# PRELIMINARY DRAINAGE REPORT

## CROSSROADS MIXED USE EL PASO COUNTY, COLORADO

NOVEMBER 2020

PCD Filing No.:  
SP-20-011

**FIRM PANEL W/ REVISED LOMR**

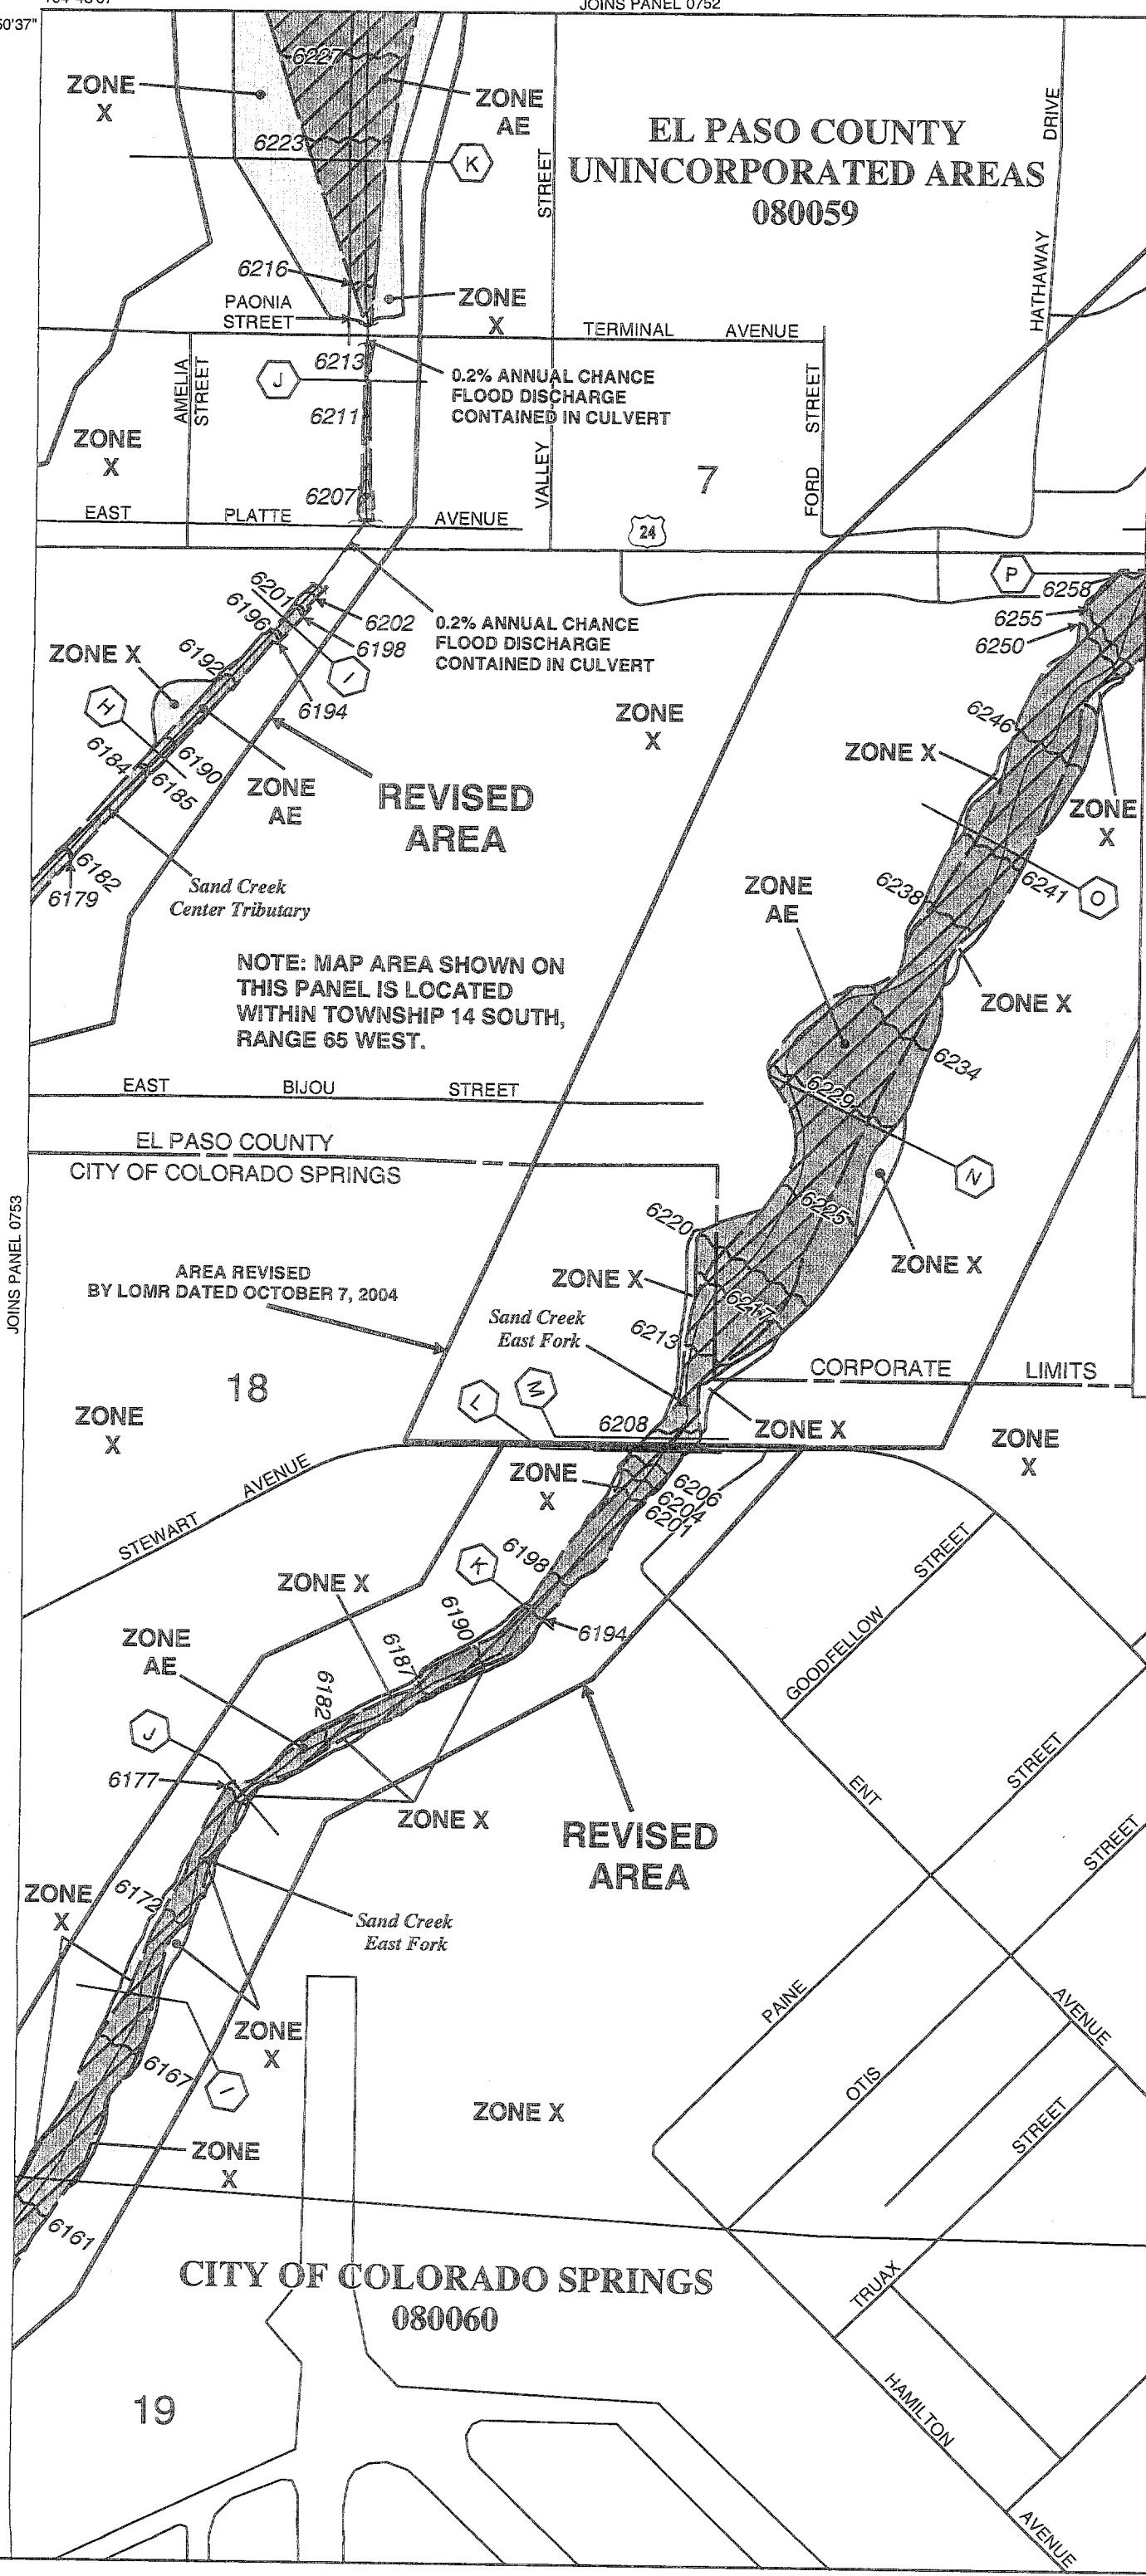
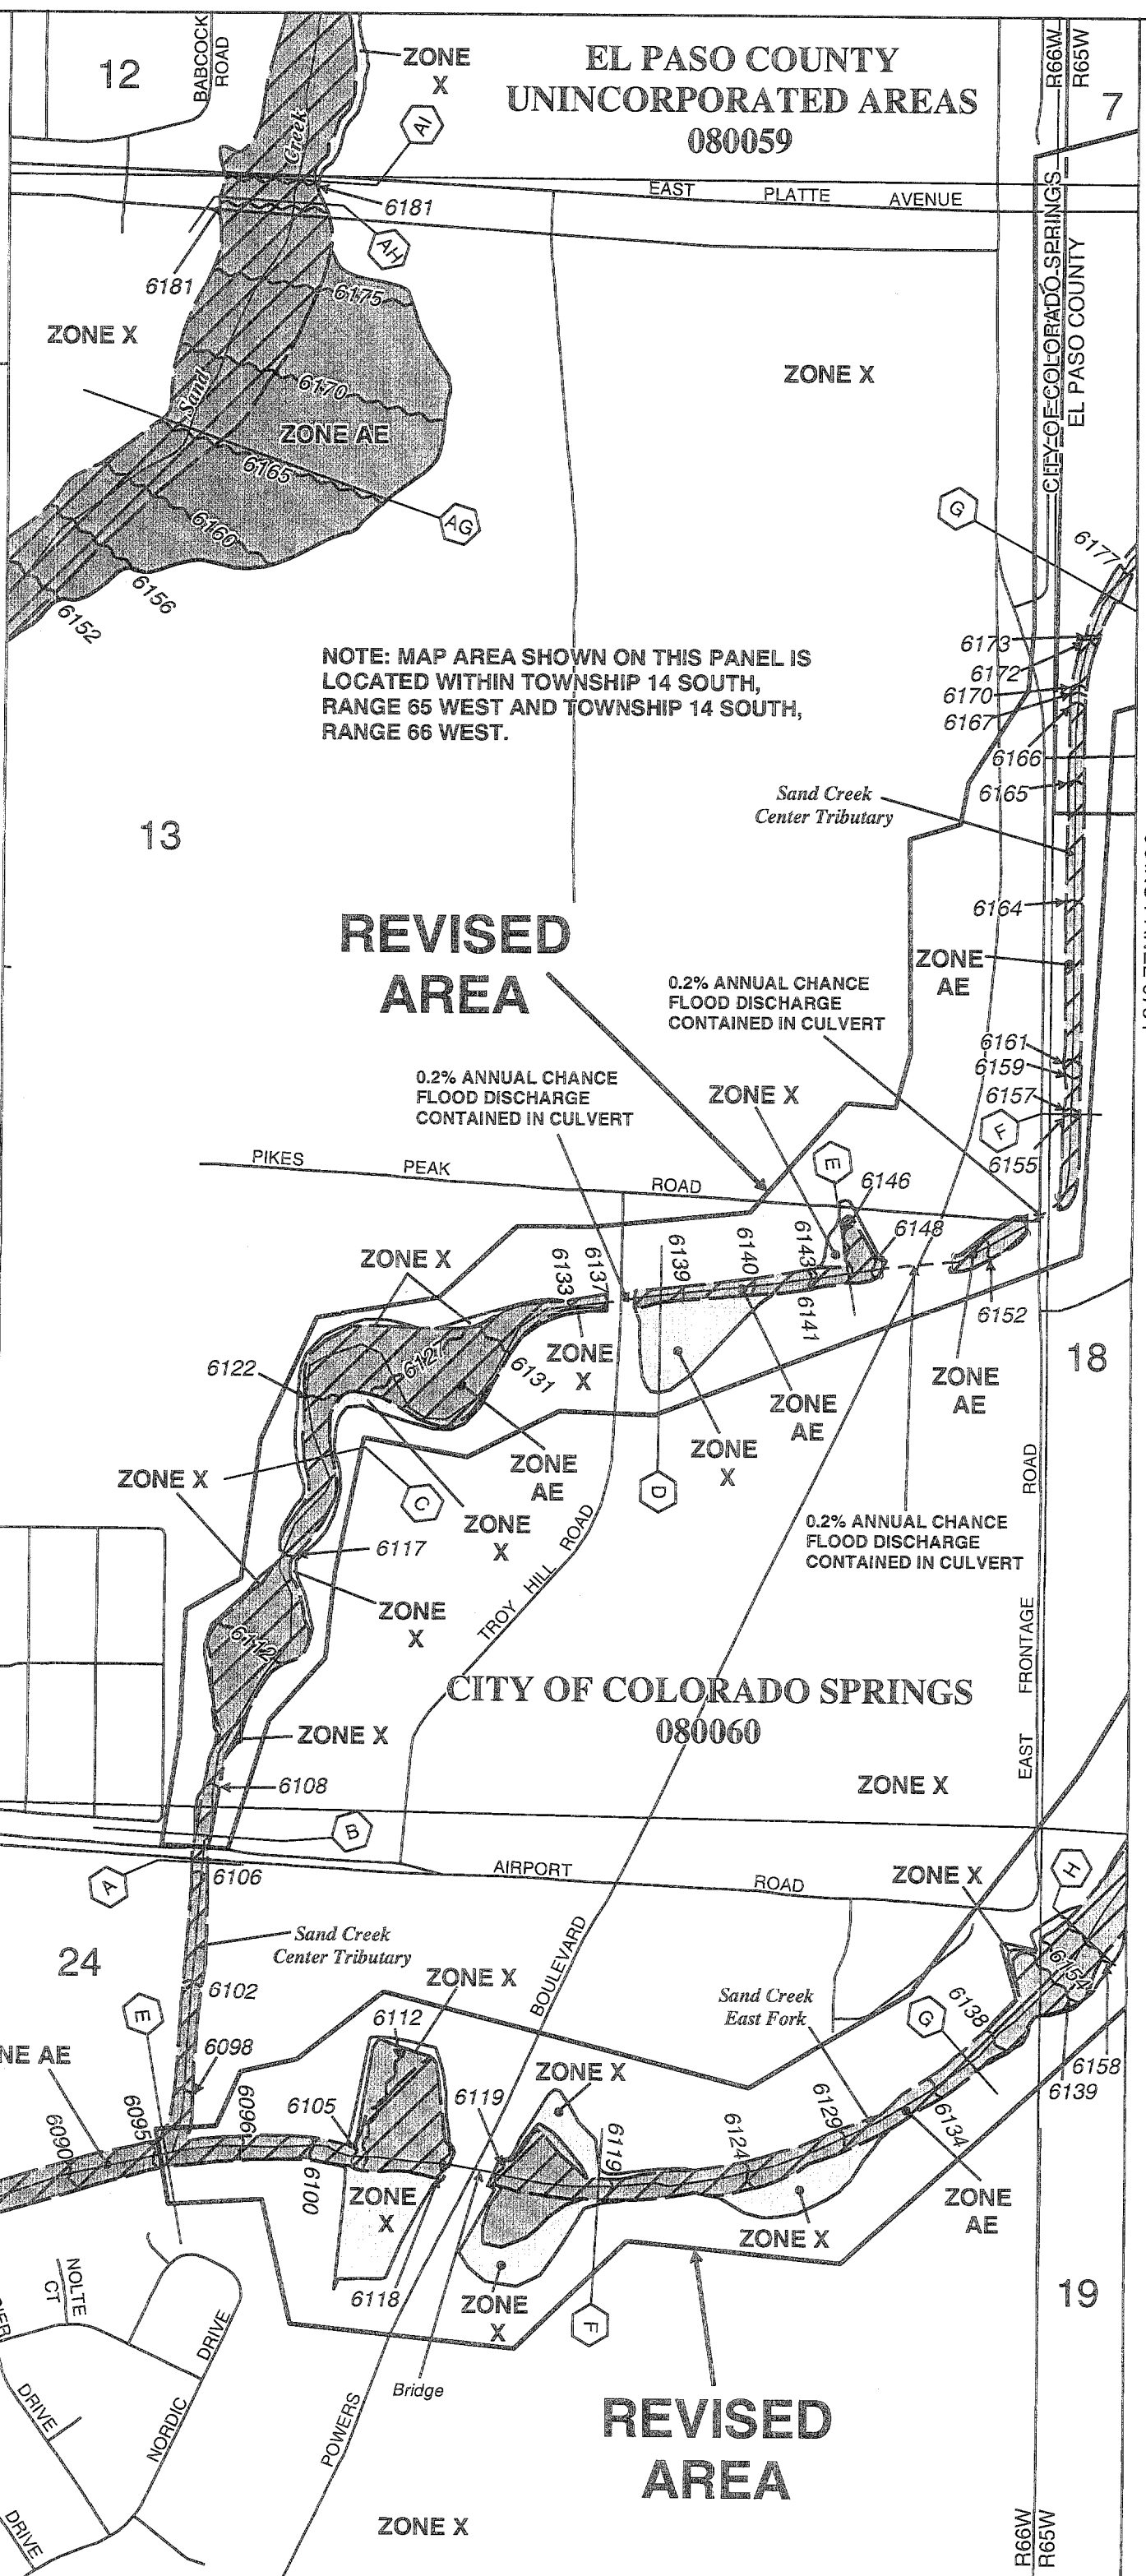
Replace the FEMA panel with the latest version which has an effective date of 12/7/2018.  
If the LOMR was incorporated in the latest FEMA FIRM then it does not need to be included.

## Routed Hydrograph Results

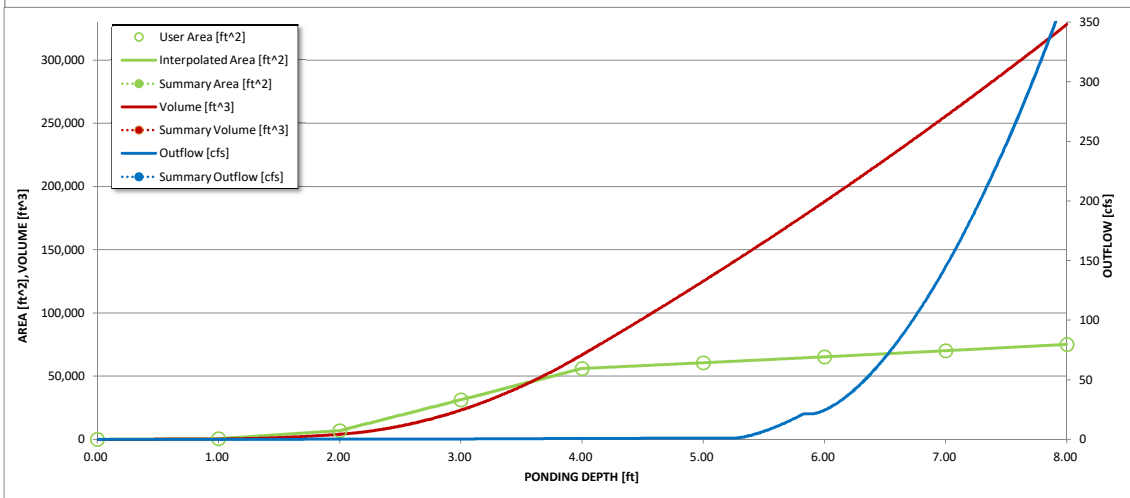
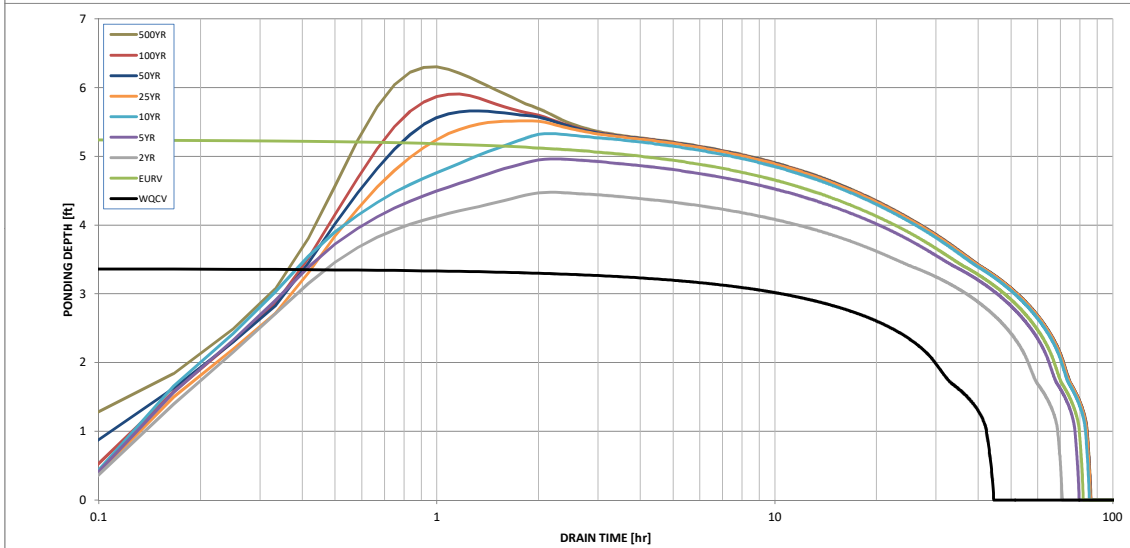
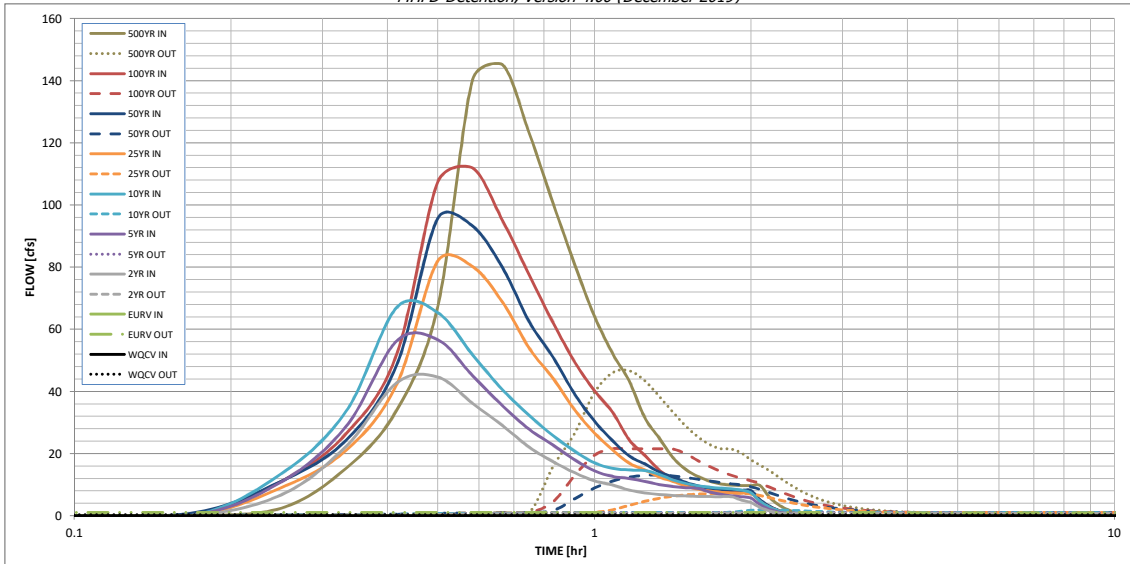
Revise. Must be at or below predevelopment

EXISTING DRAINAGE MAP  
CROSSROADS MIXED USE  
JOB NO. 18-003  
DATE PREPARED: SEPTEMBER 18, 2020  
DATE REVISED:

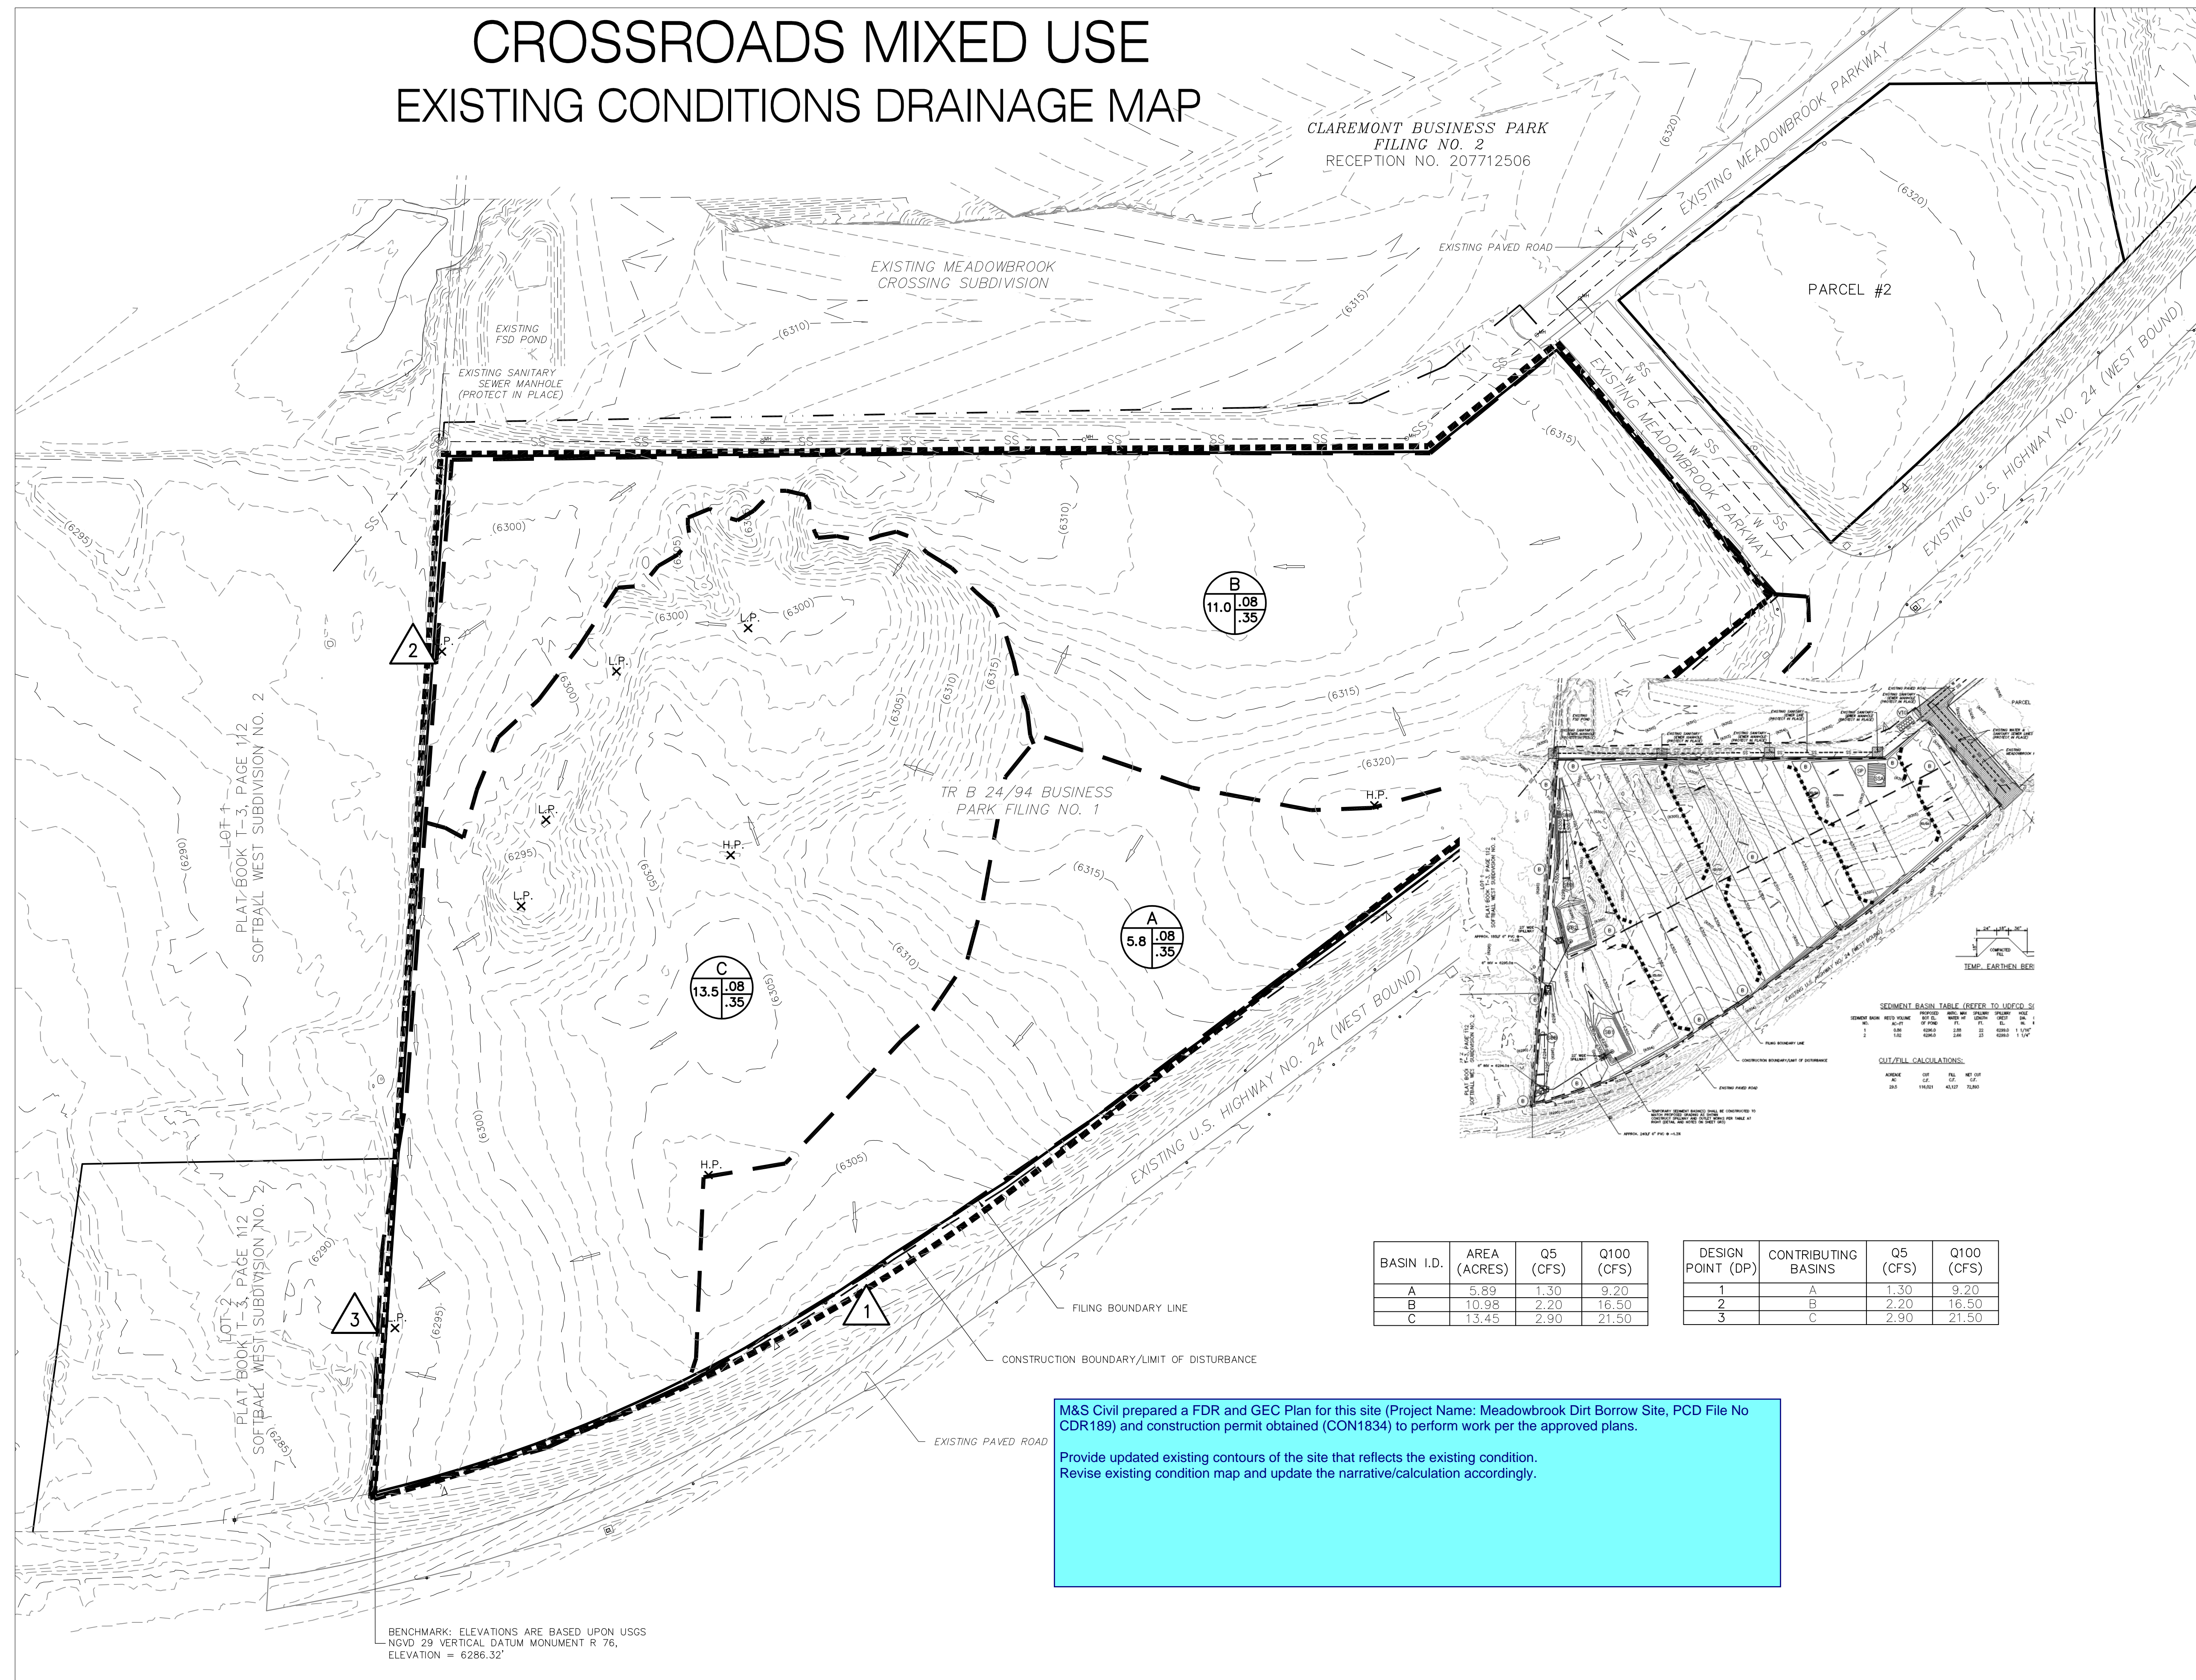
Provide updated existing contours of the site that reflects the existing condition.  
Revise existing condition map and update the narrative/calculation accordingly.
